Change

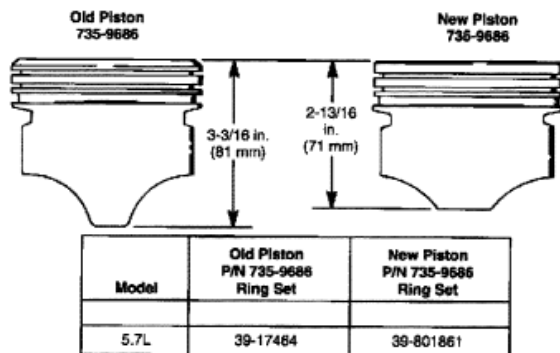
The latest replacement standard pistons (P/N 735-9686) for these engines use a different set of piston rings. The latest piston's oil ring groove is not as deep as the older piston.

The latest replacement piston will be shipped with a set of piston rings.

If piston rings only are required, refer to the drawings before ordering replacement piston ring sets from the chart.
